AFFORDABLE HOUSING
DEVELOPMENT SSD-83256463
ARCHITECTURAL DRAWINGS
THE BOULEVARDE
PUNCHBOWL
COLLINS AND TURNER
SEPTEMBER 2025

No	Date	By	Note
B	9/12/2025	DC	For RTS

Project	
Affordable Housing Development SSD-83256463 150 The Boulevard and 34 Dudley Street Punchbowl, NSW

Drawing Title Basement Plan

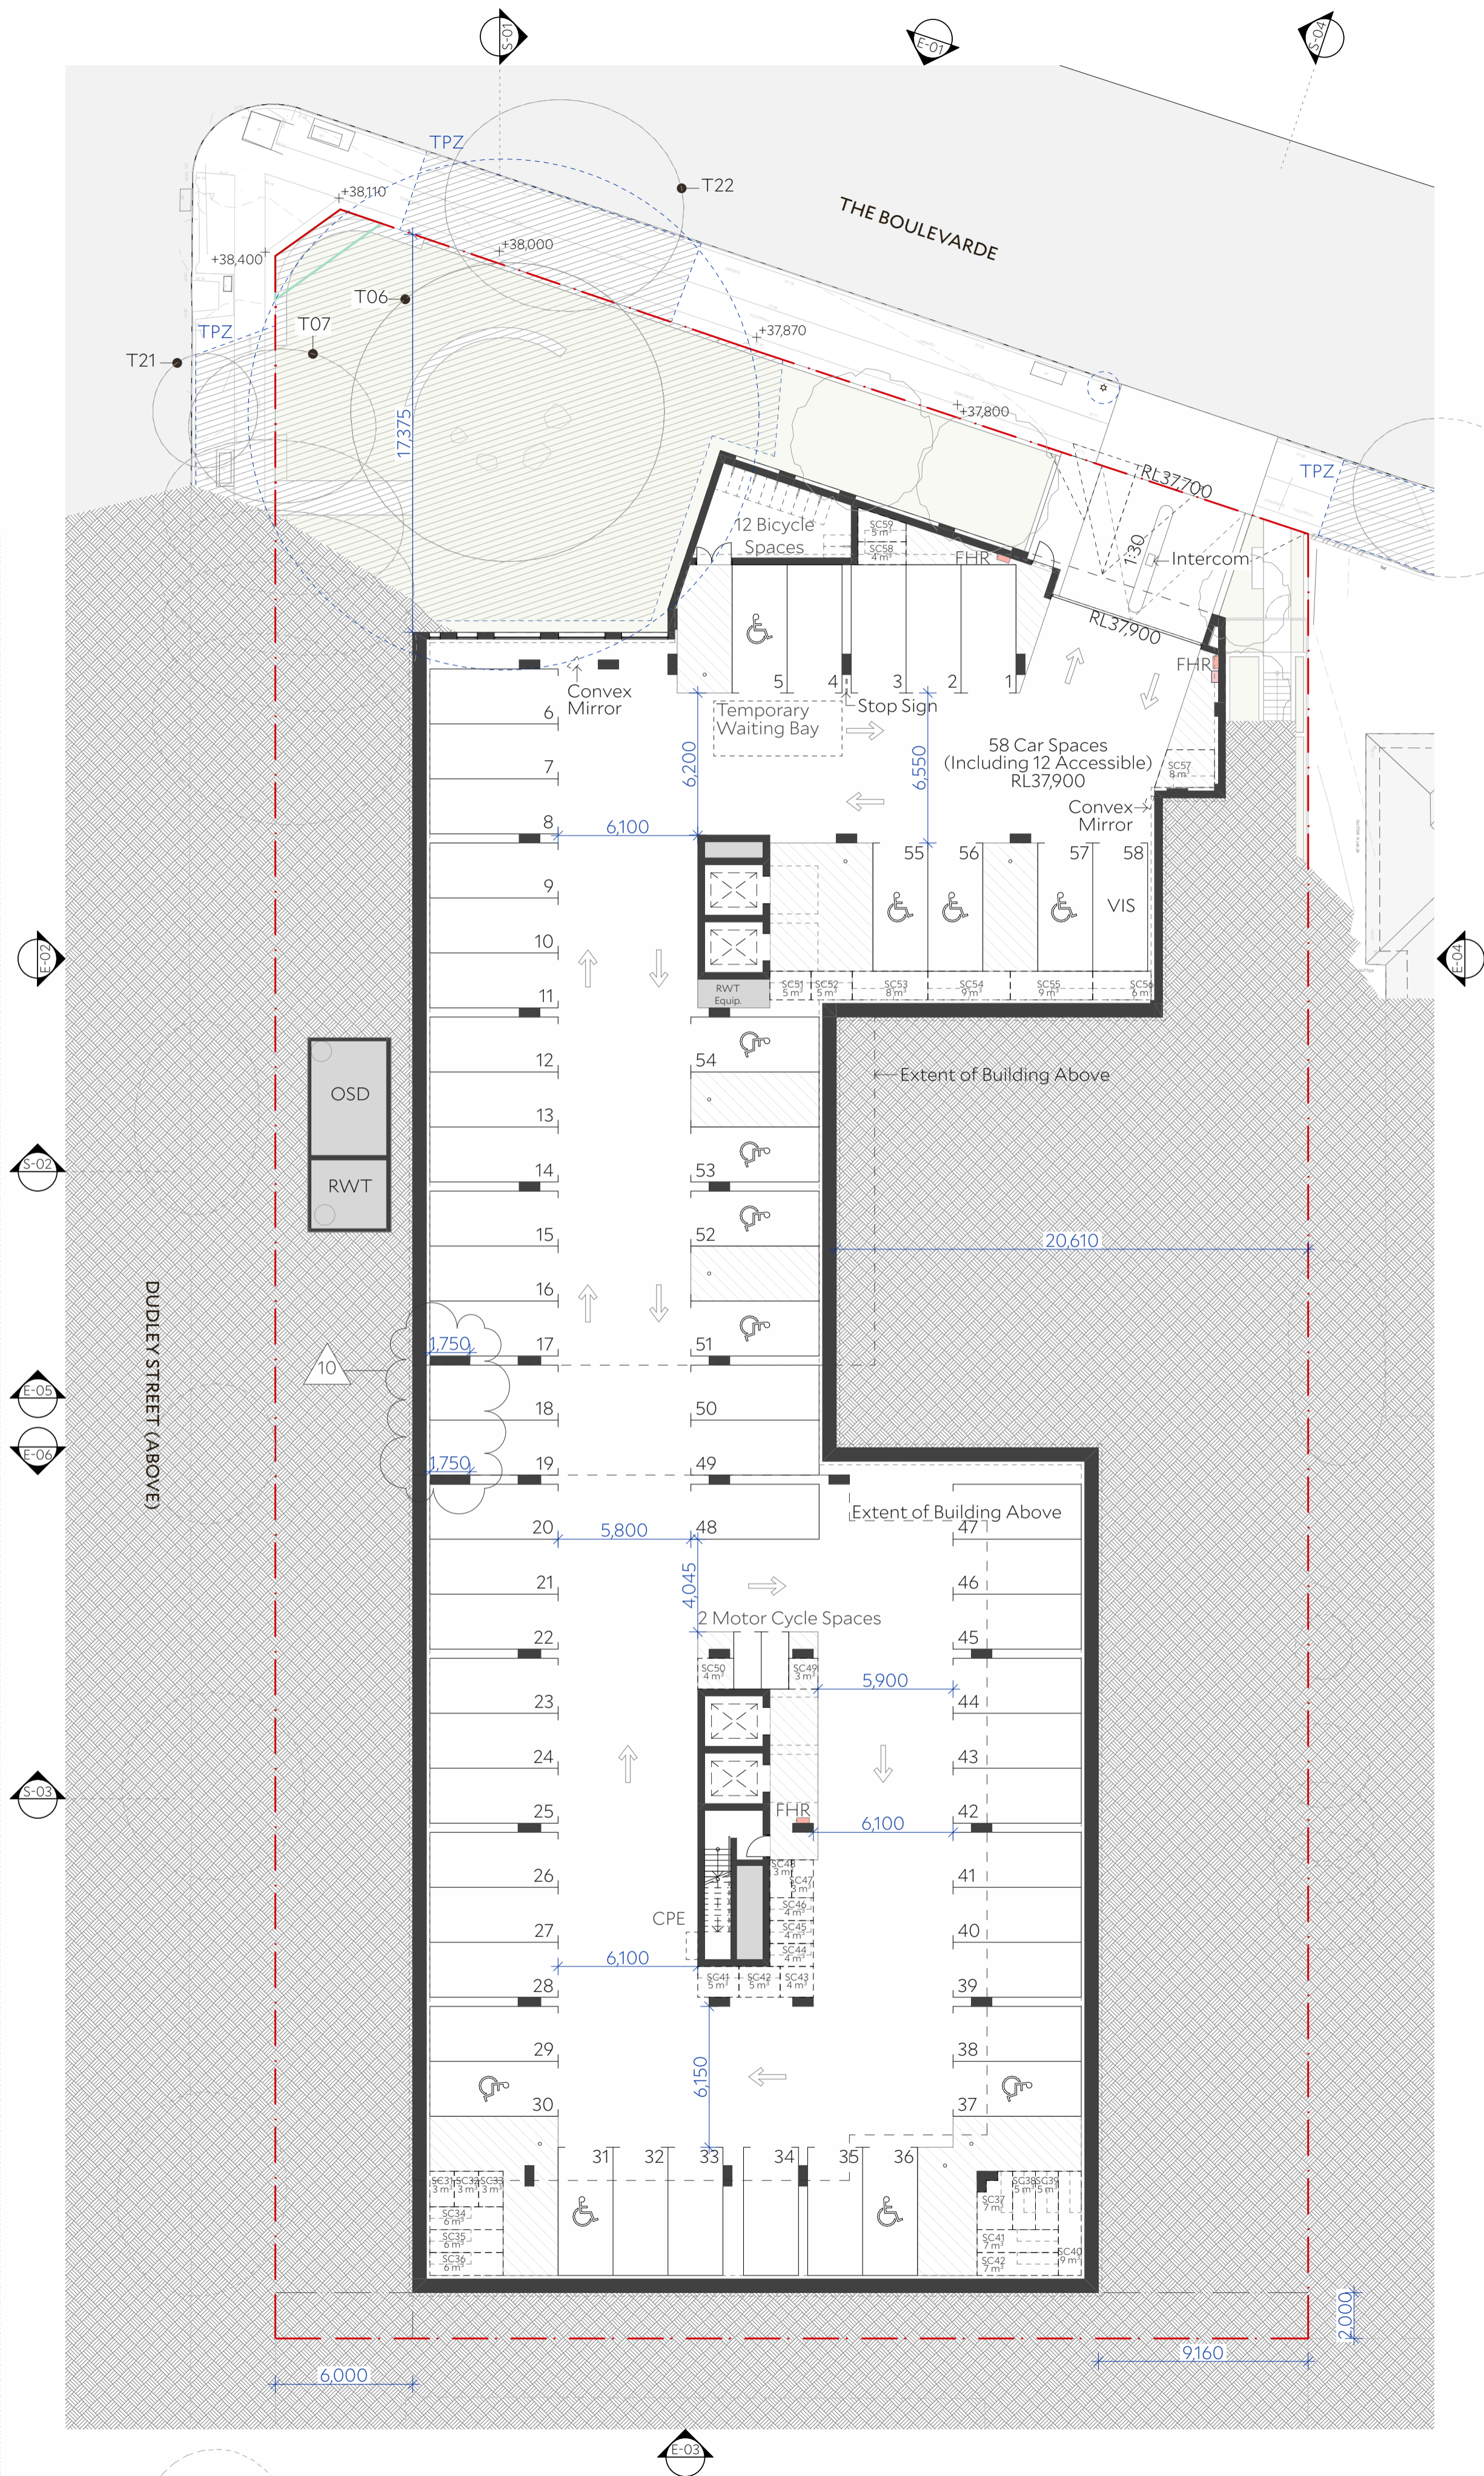
ID	Name
10	Column size adjusted Refer to RTS Item CB-E 1.3

Drawing Title North and West Elevation

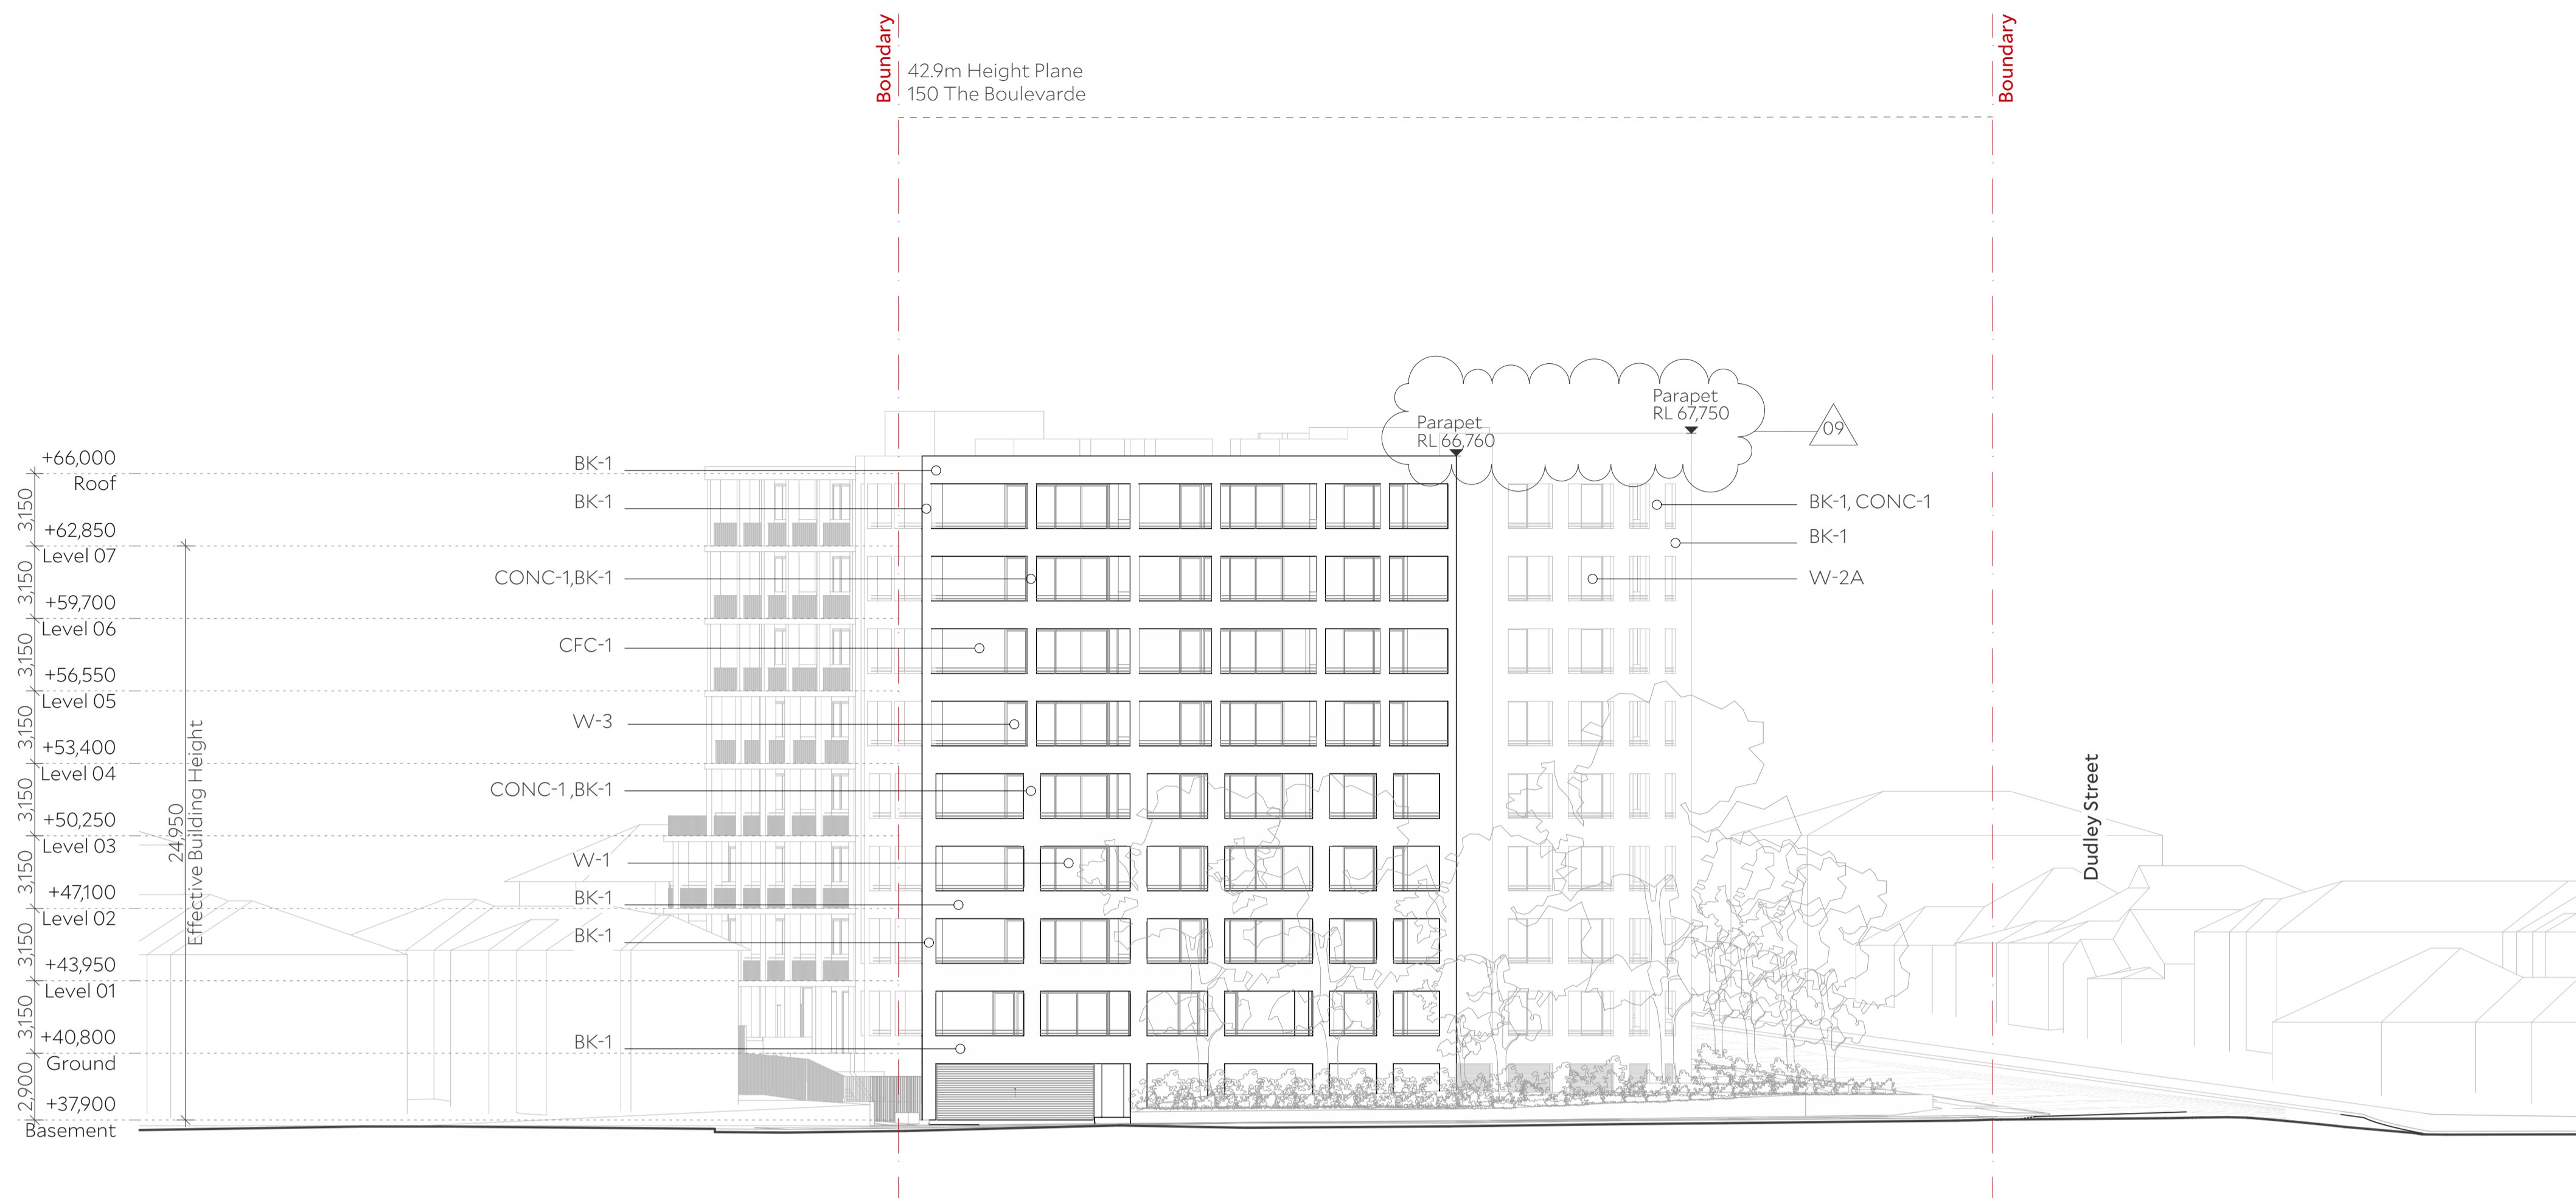
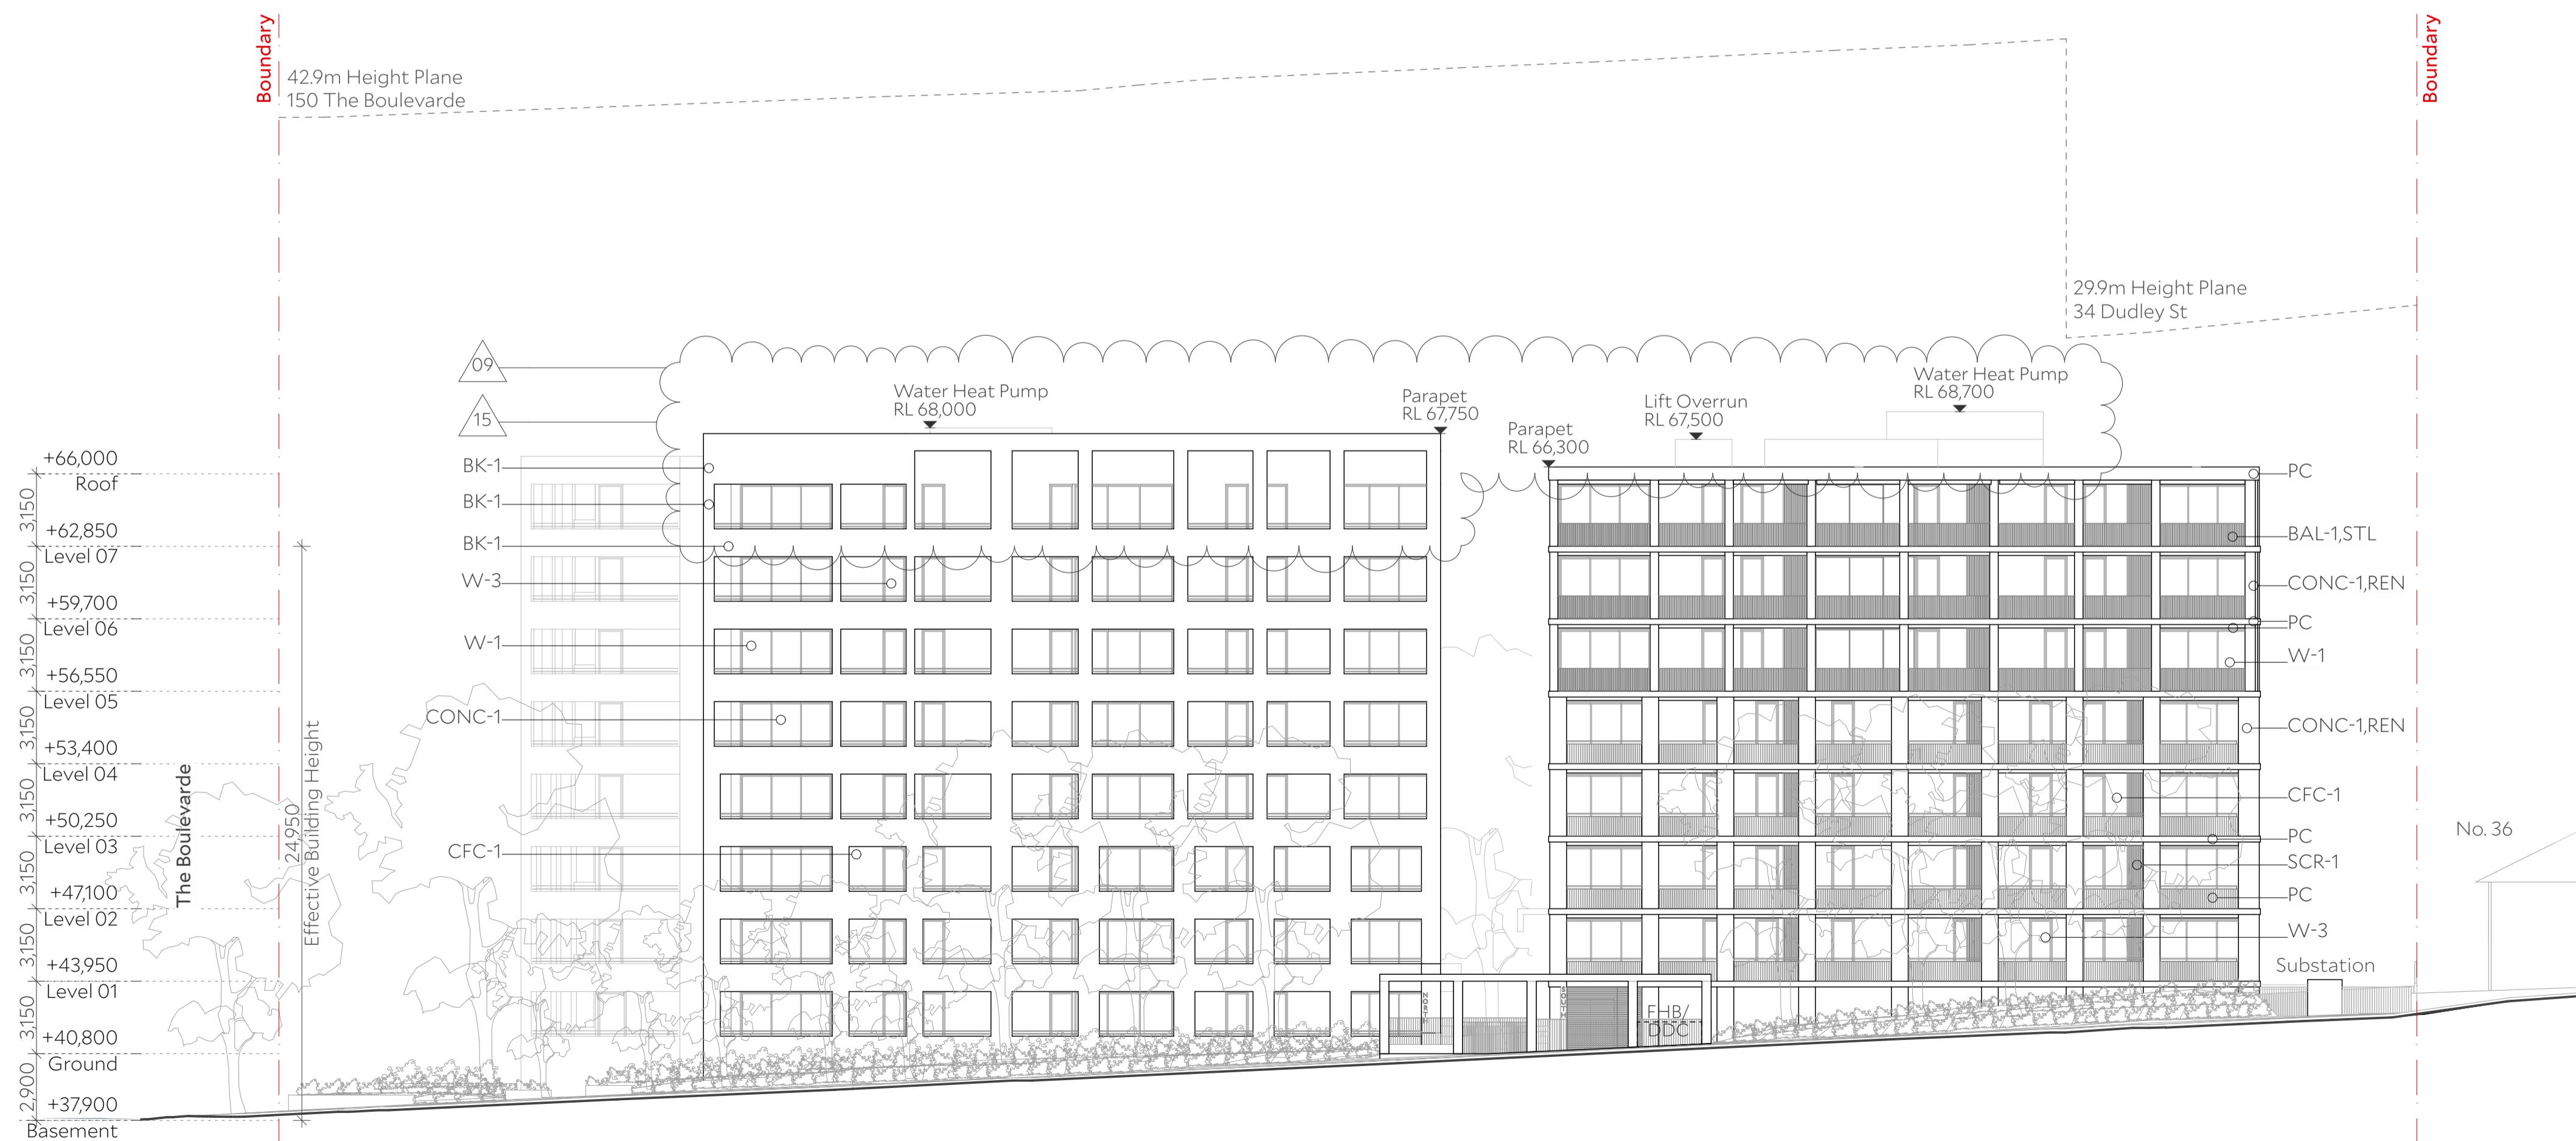
ID	Name
09	Reduced levels added Refer to RTS Item DPHI 14
15	Facade adjusted Refer to RTS Item CB-UD3.1
